EQUIPMENT/FURNISHINGS - SEAT PAN TILT BLOCKING TAB INSTALLATION

CIL-25-03
Page 1 of 1

Model 2050 Seating System: Seat Pan Tilt Blocking Tab Installation

Document No: SB2050-25-20-03
Revision: IR
Date: 1/15/2020

Figure 2.1 Modification ID Label and Protective Film Location

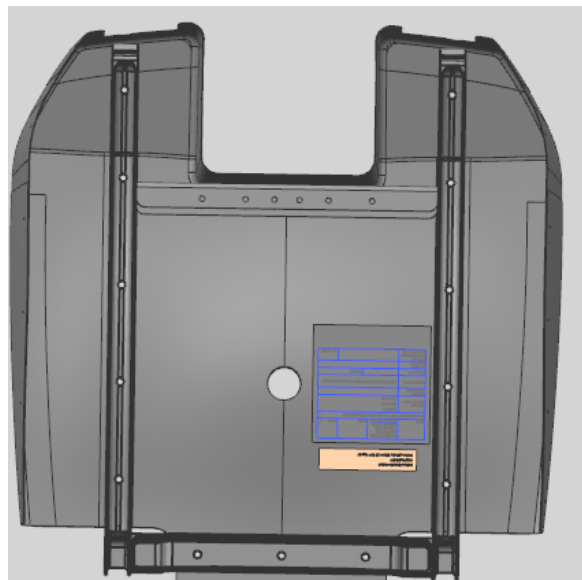
The new SB label should be installed on the bottom side of the composite seat pan as close to the existing seat ID label as space allows.

- A. Install 9000-1130008-001 Modification ID Label adjacent to the existing TSO ID label (or adjacent to existing modification labels) approximately as shown in Figure 2.1

Figure 3.1 Stack-up Sequence

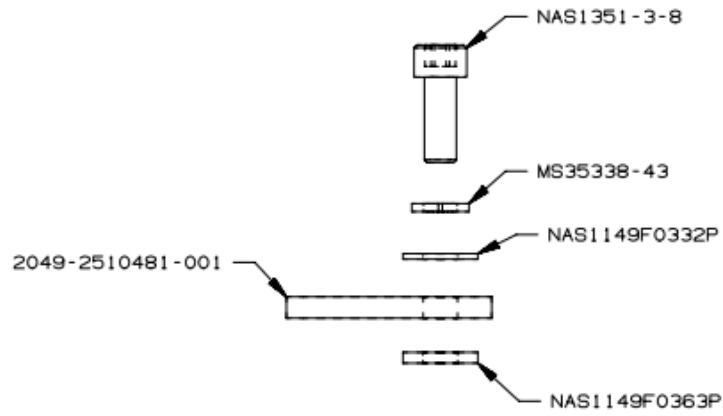
- A. The modification to the seat shall be performed outside the airplane (i.e. seat not installed).
- B. For best access it is recommended to adjust the seat to highest position with the seat pan tilt option adjusted “full up”.
- C. Stack the blocking tab with screw and washers per Figure 3.1
- D. Locate and orient the cable end fitting per Figure 3.2.
- E. Orient the blocking tab per Figure 3.3
- F. Install the blocking tab onto the cable end fitting using unused threaded hole in the cable end fitting (both sides). See Figure 3.2.
- G. Final check installation. See Figure 3.4 for the final configuration.

Figure 3.2 Cable End Fitting

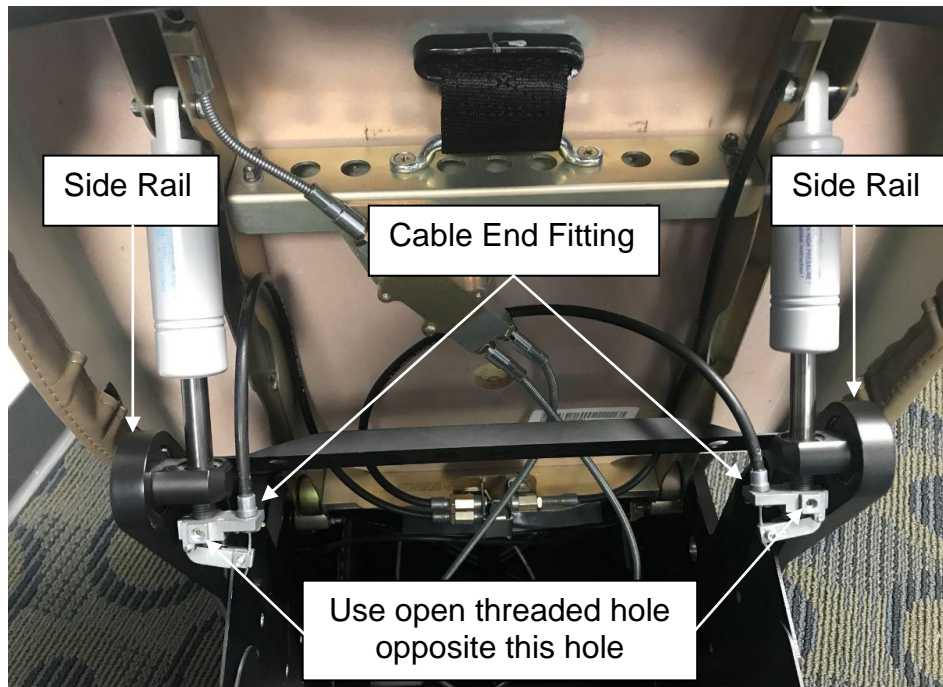
Note that this condition can also be remedied by simply rotating the cable end fittings to the position shown in Figure 3.2; however, this remedy does not prevent the fitting from rotating or being forced back to the discrepant position.

Figure 2.1 Modification ID Label and Protective Film Location

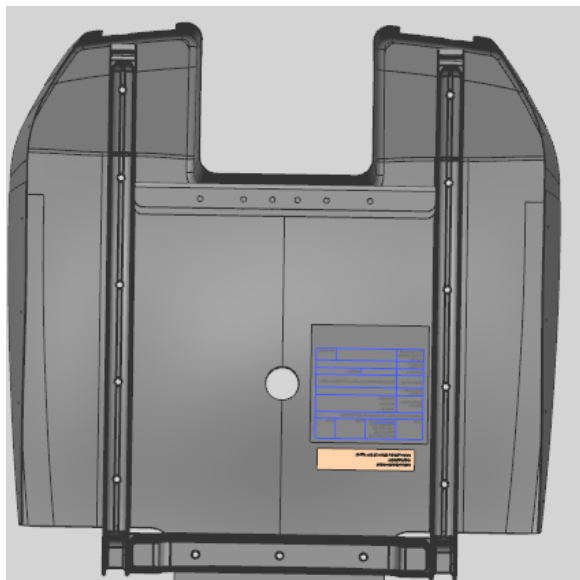
The new SB label should be installed on the bottom side of the composite seat pan as close to the existing seat ID label as space allows.

- A. Install 9000-1130008-001 Modification ID Label adjacent to the existing TSO ID label (or adjacent to existing modification labels) approximately as shown in Figure 2.1

Figure 3.1 Stack-up Sequence

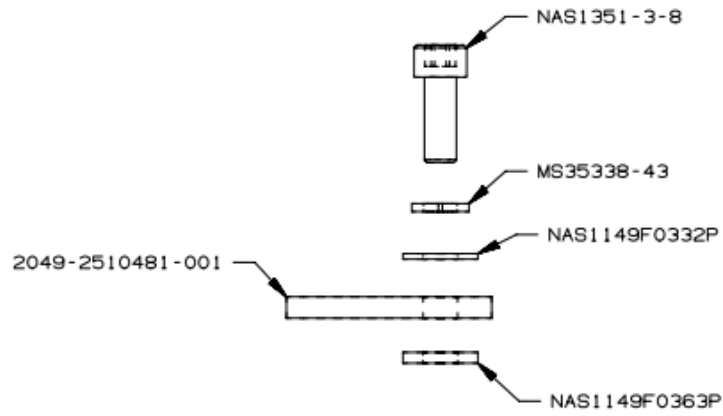
- A. The modification to the seat shall be performed outside the airplane (i.e. seat not installed).
- B. For best access it is recommended to adjust the seat to highest position with the seat pan tilt option adjusted "full up".
- C. Stack the blocking tab with screw and washers per Figure 3.1
- D. Locate and orient the cable end fitting per Figure 3.2.
- E. Orient the blocking tab per Figure 3.3
- F. Install the blocking tab onto the cable end fitting using unused threaded hole in the cable end fitting (both sides). See Figure 3.2.
- G. Final check installation. See Figure 3.4 for the final configuration.

Figure 3.2 Cable End Fitting

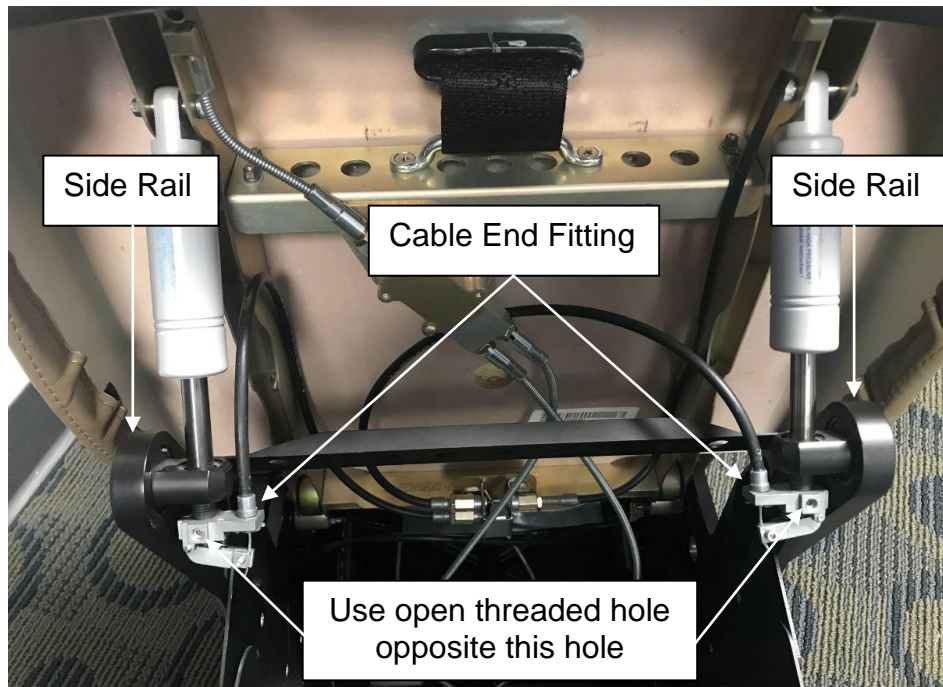
Note that this condition can also be remedied by simply rotating the cable end fittings to the position shown in Figure 3.2; however, this remedy does not prevent the fitting from rotating or being forced back to the discrepant position.
